ASU CREST Center

Jonesboro, Arkansas

Pre-Bid RFIs

5/28/2026

③ CEILING DETAIL

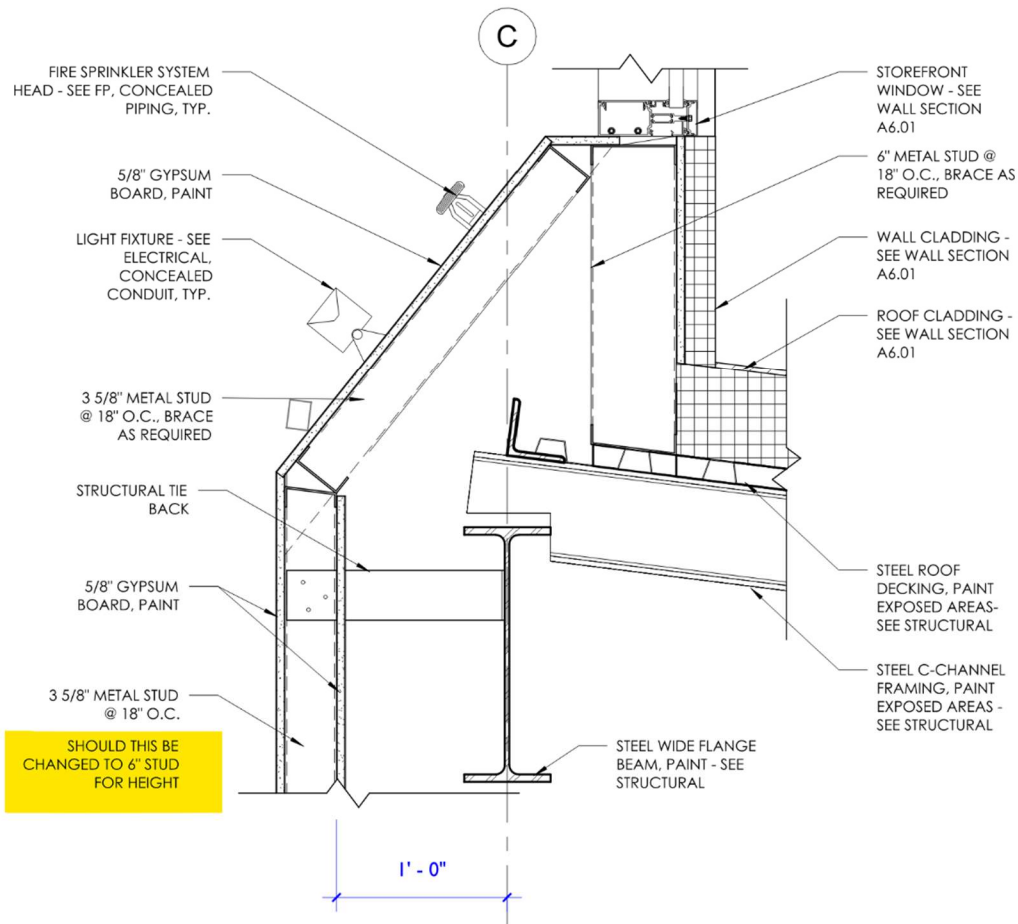
13. RE: 3/A2.31 (image below) - Does this need to be a 6" stud? **The 3 5/8" is good (since it is strapped back).**
